ULNRC- 04558

**DOCKET NUMBER 50-483
CALLAWAY PLANT
UNION ELECTRIC COMPANY
RESPONSE TO REQUEST FOR ADDITIONAL INFORMATION
ON REVISION TO TECHNICAL SPECIFICATION 5.5.9
"STEAM GENERATOR (SG) TUBE SURVEILLANCE PROGRAM"**

**REQUEST FOR ADDITIONAL INFORMATION
REVIEW OF THE CALLAWAY PLANT APPLICATION
FOR REVISION TO TECHNICAL SPECIFICATION 3/4.4
TAC NUMBER: MB1214**

Figure R6-27

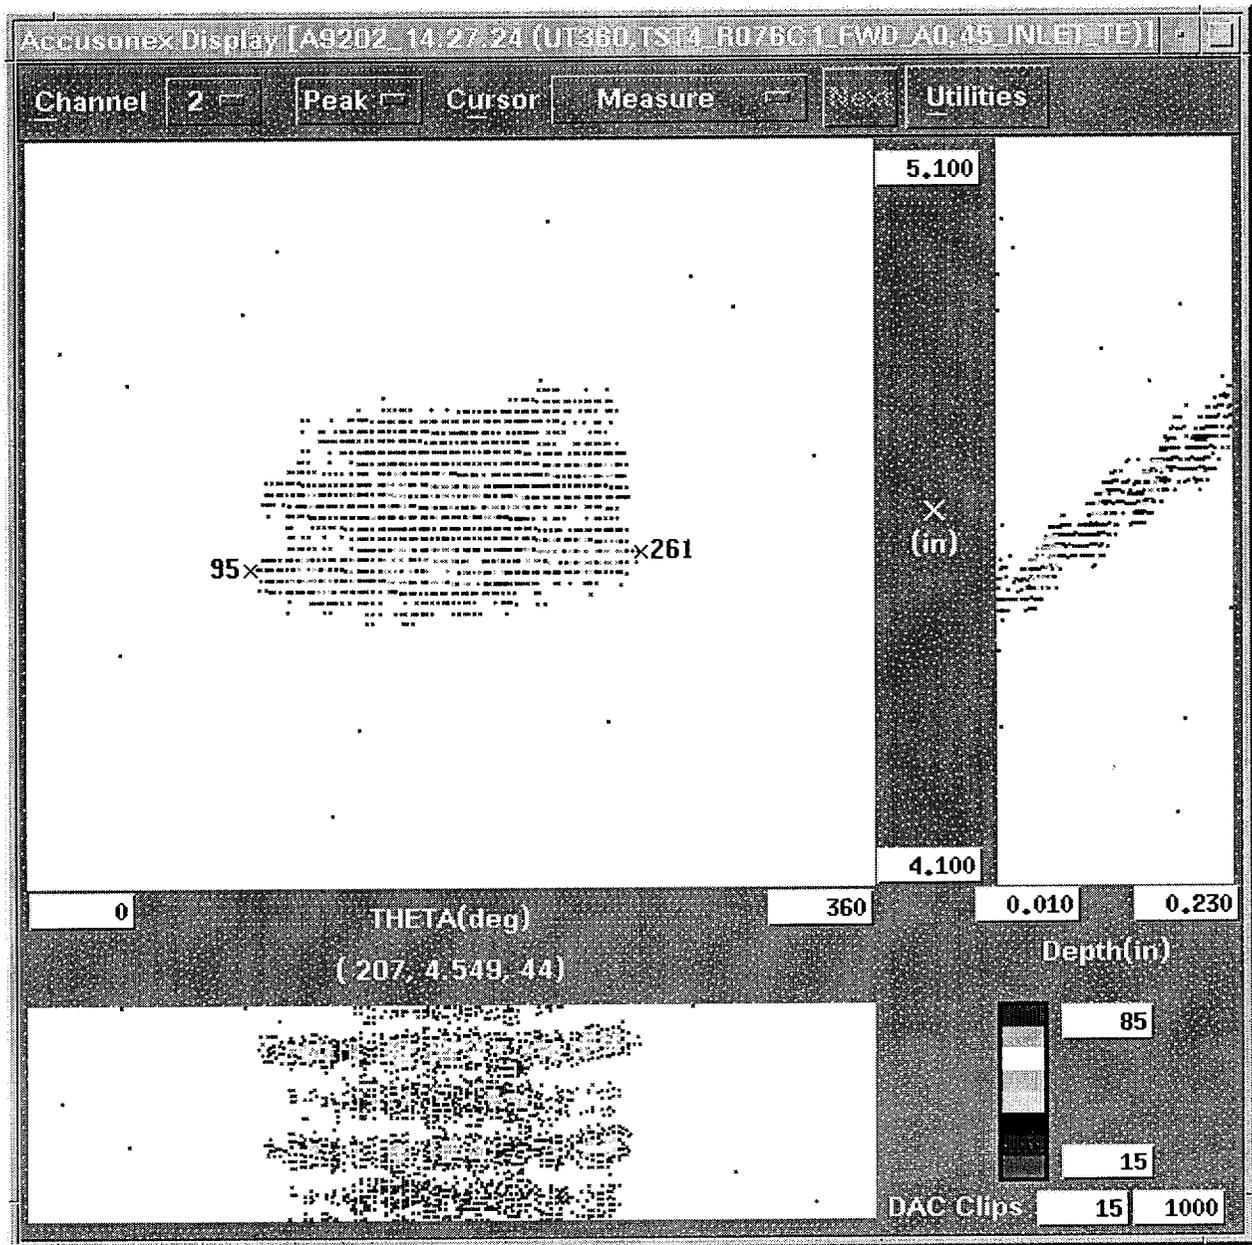
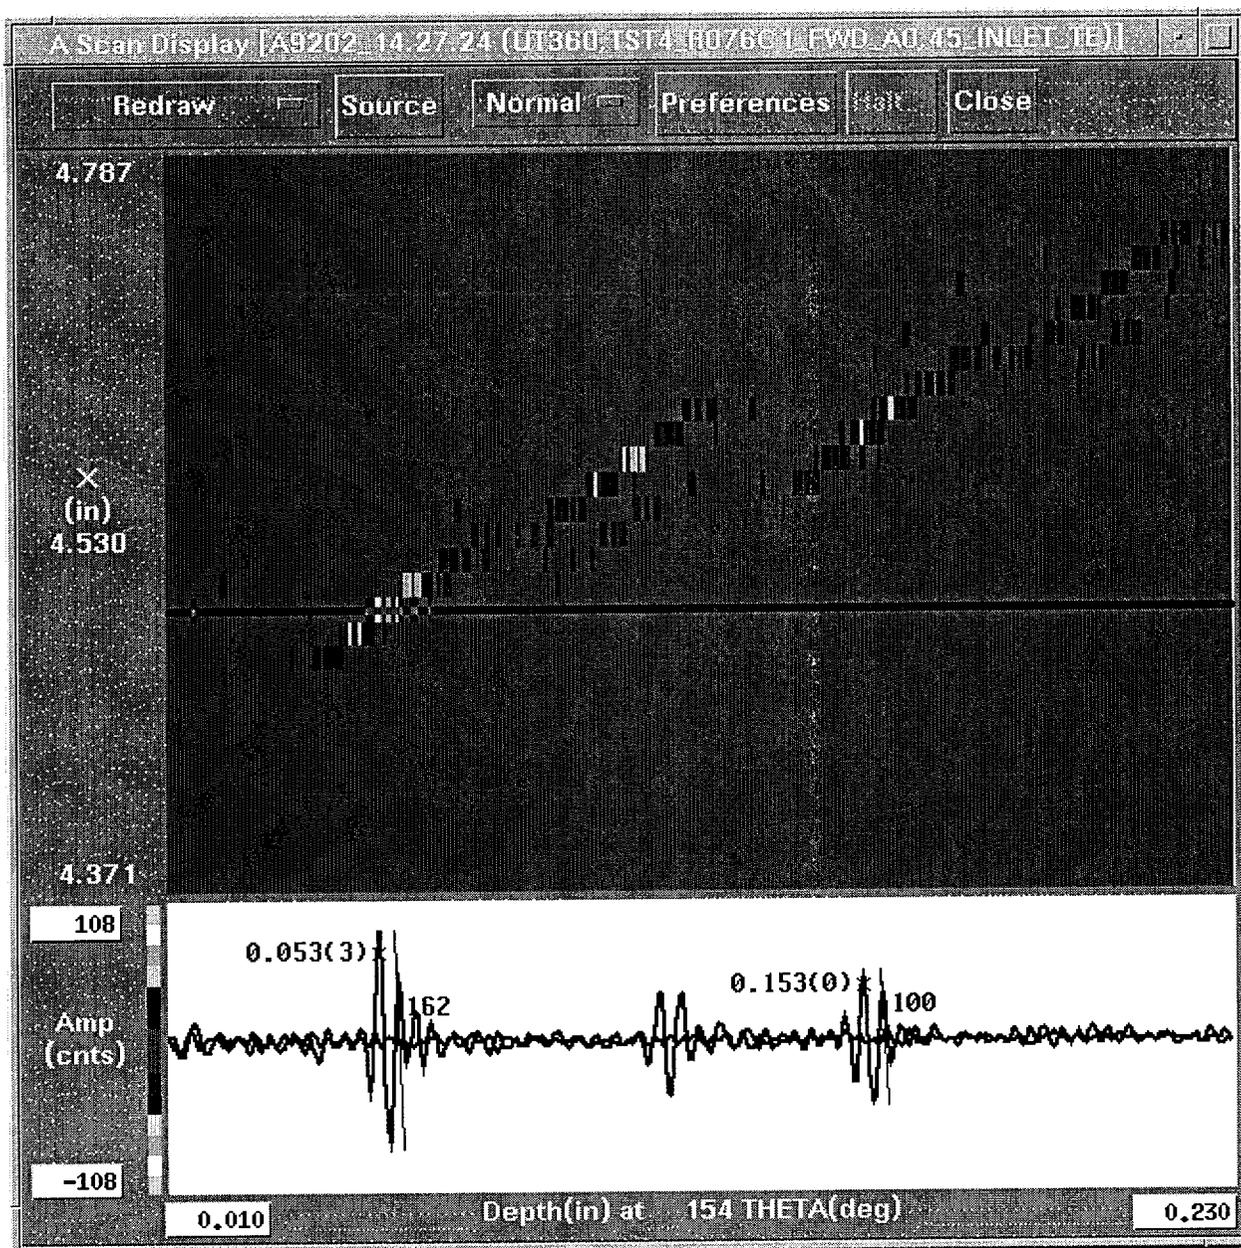
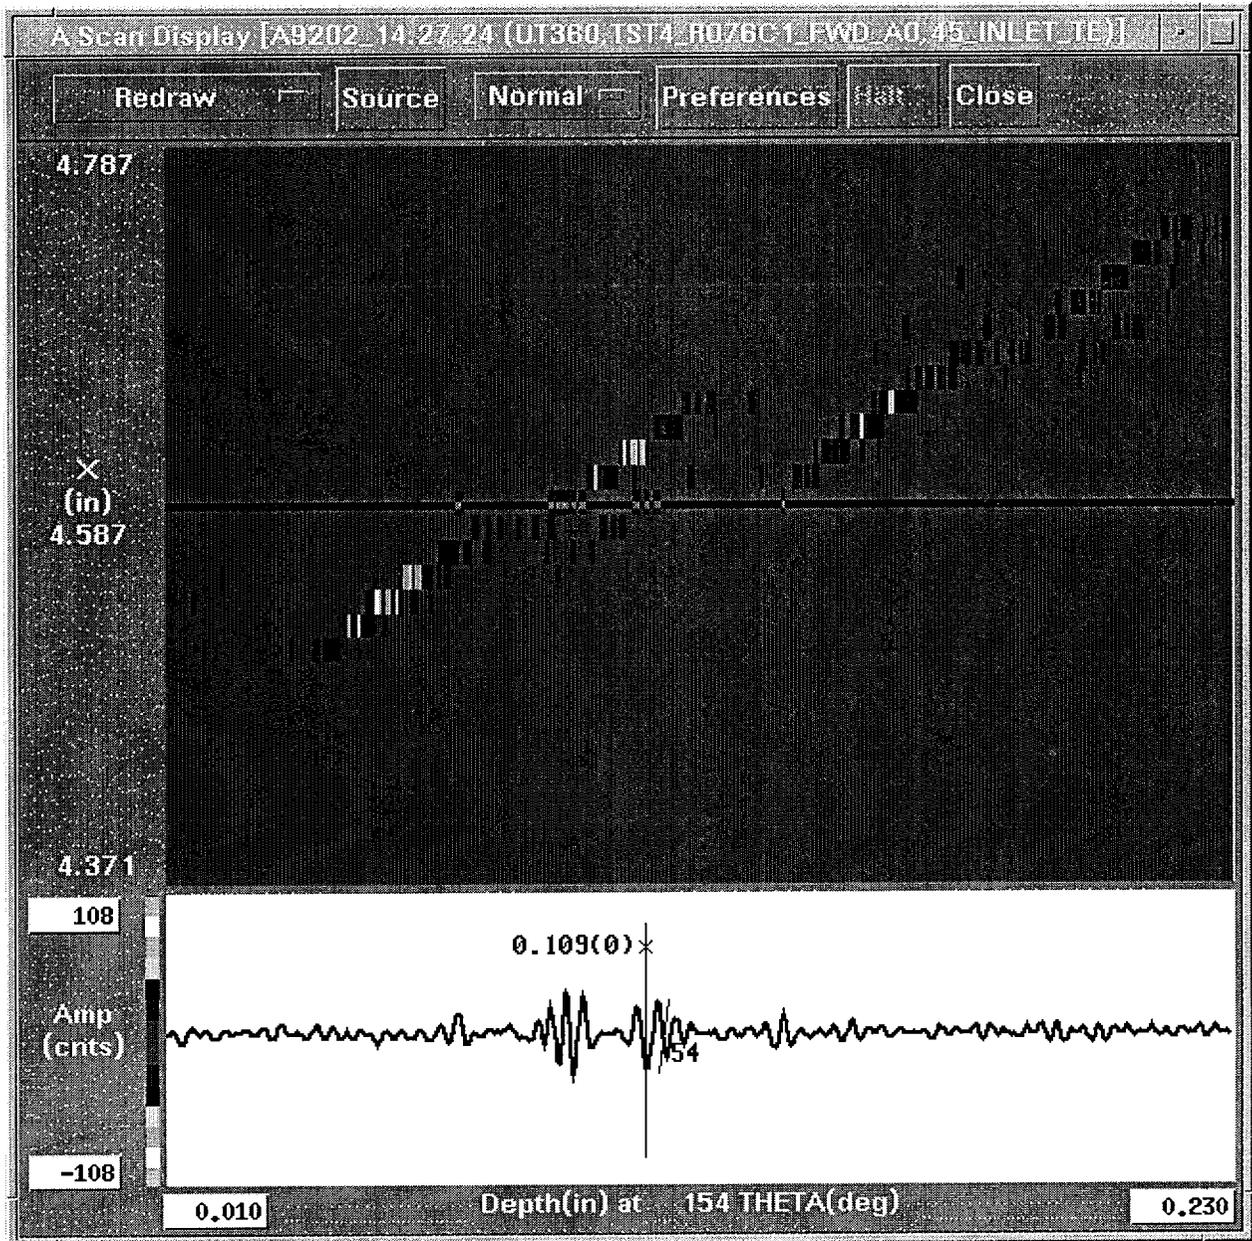
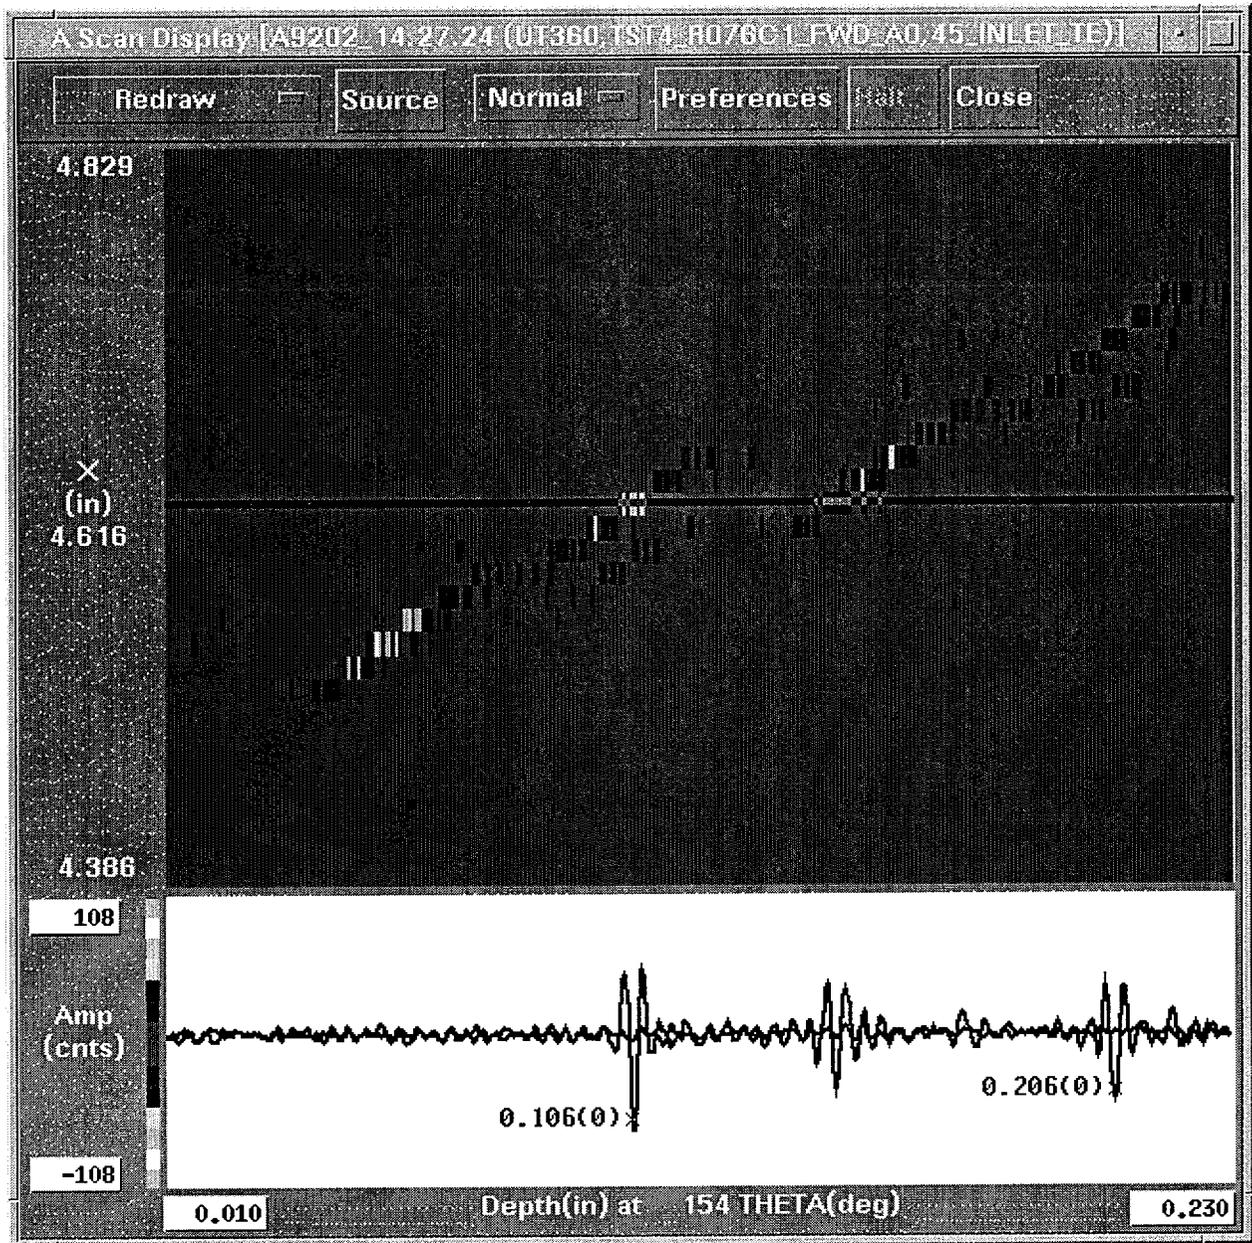
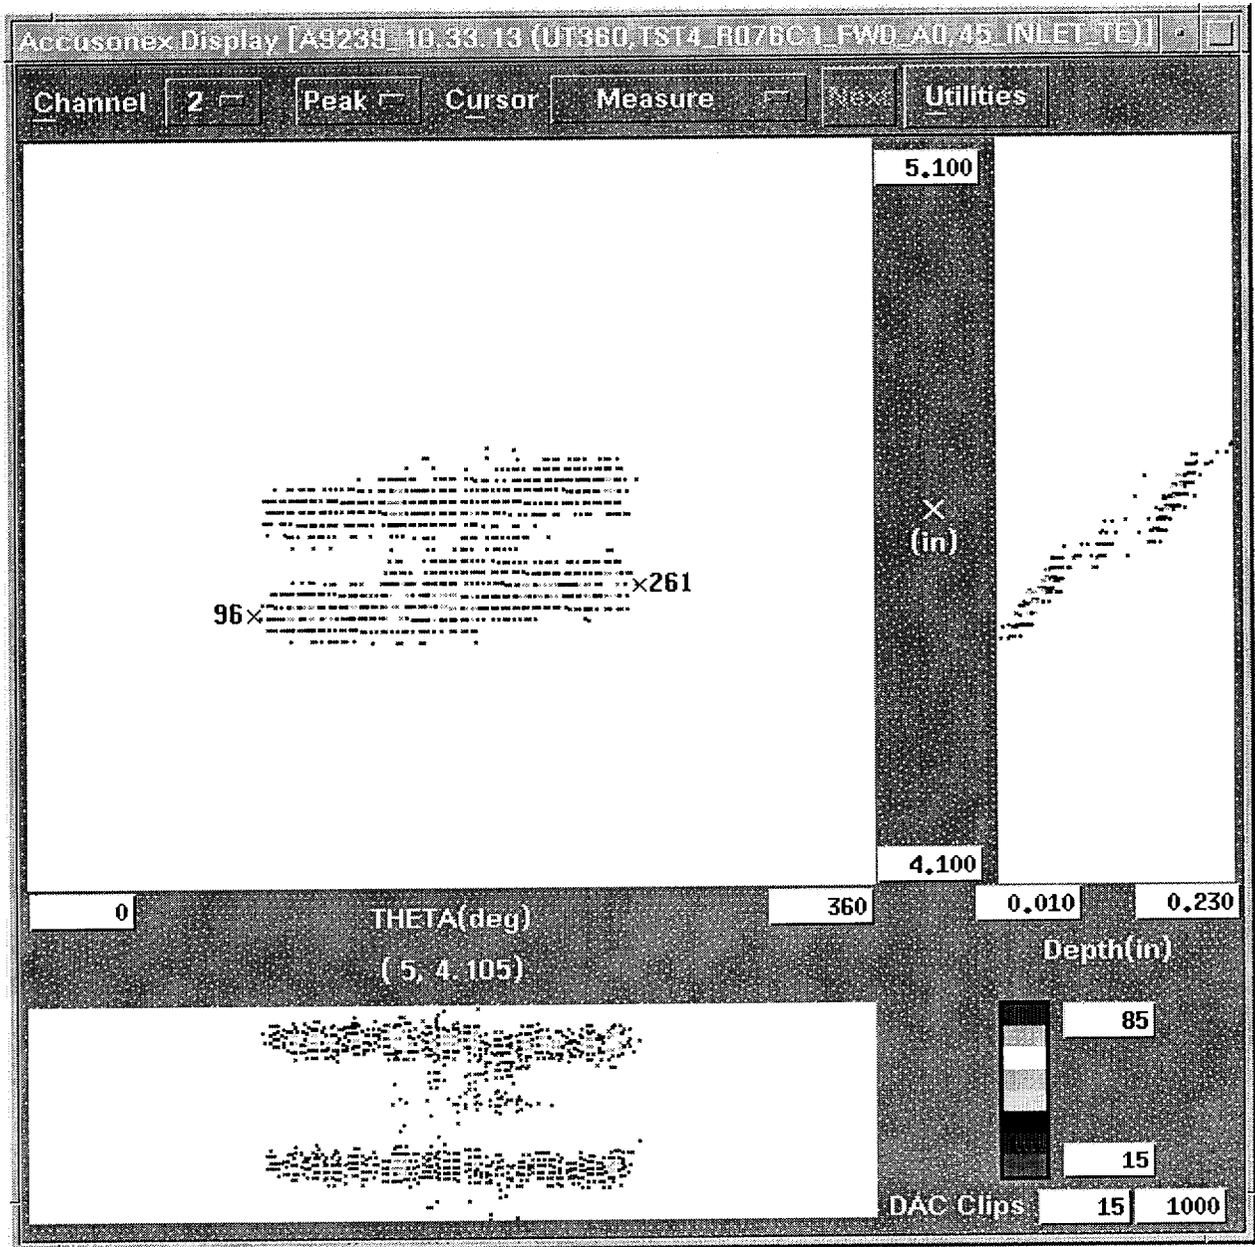
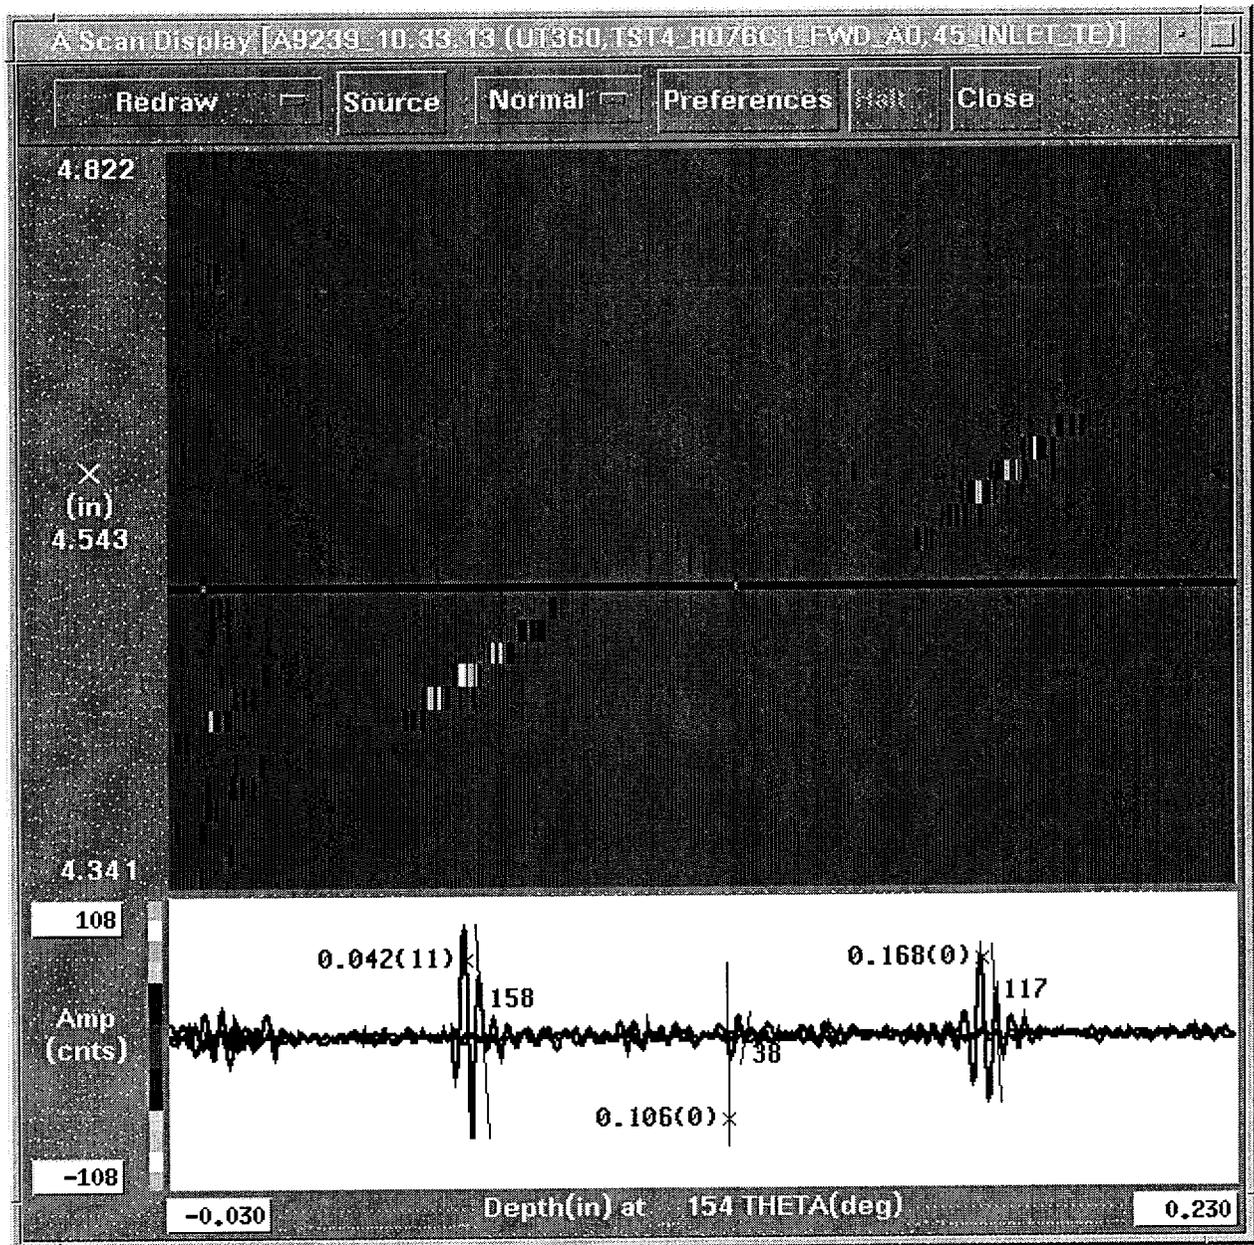
RAI # 6. During the meeting, FTI indicated that PWSCC detectability in the sleeve could be inferred from the ID notches in the UT calibration standards and the data sets containing pits. It is not clear to the staff how detecting EDM notches in the calibration standards or another degradation morphology such as pits would infer an ability to detect tight flaws such as PWSCC. Explain the basis for the statement that sleeve PWSCC ID defects will be detected, and the resulting sensitivity and POD, since the peer review (ETSS # 98404) only covers volumetric defects. Please provide additional discussion or, preferably, additional data to support the claims of the capability of the technique to detect PWSCC in the sleeve. (Question from the 6/7/01 meeting held with UE, FTI, and the NRC staff)

During the fatigue cycling, fatigue cracks developed in the sleeve wall at the inner diameter crack site as well as at the outer diameter crack site. The post fatigue portion of this presentation will show the return of the full skip reflection at the inner diameter crack location as well as the increase in the FSN result for the outer diameter crack.

This is the pre-sleeve C-Scan plot of the ODSCC circumferential crack in tube TST4-076-1. The outer diameter crack extent (length) can be estimated from the C-Scan plot as $(261 - 95)$ or 166 degrees. The plot shows the presence of a half skip response, a one and one half skip response and a considerable amount of full skip and two skip reflections.

This is the A-Scan plot showing the half skip (0.053) and the one and one half skip (0.153) reflections associated with the outer diameter crack at the 154 degree location. Their amplitudes (162, 100), along with the full skip reflection amplitude (next plot), will be used to calculate a FSN result.

This is the A-Scan plot showing the full skip reflection associated with the outer diameter crack at the 154 degree location. The half skip (first outer diameter reflection) was the waveform 0.053 with a 162 count amplitude. The full skip (first inner diameter reflection) is the waveform 0.109 with a 54 count amplitude. The one and one half skip (second outer diameter reflection) was the waveform 0.153 with a 100 count amplitude. The calculated FSN value is $(54 / ((162 + 100) * .5))$ or 0.41. The regression equation would be solved as $(0.050 - (0.031 - 0.031 * 0.41))$ or 0.032 inch..

This is the post sleeve (pre-fatigue) C-Scan plot of the ODSCC circumferential crack in tube TST4-076-1. The outer diameter crack extent (length) can be estimated from the C-Scan plot as (261– 96) or 165 degrees. The plot shows the presence of a half skip response, a one and one half skip response and some full skip reflections between the 170 degree and 220 degree locations.

This is the post fatigue crack C-Scan plot of the ODSCC circumferential crack in tube TST4-076-1. The crack extent (length) can be estimated from the C-Scan plot as $(261 - 94)$ or 167 degrees. The plot shows the presence of a half skip response, a one and one half skip response and the return of the full skip reflections.
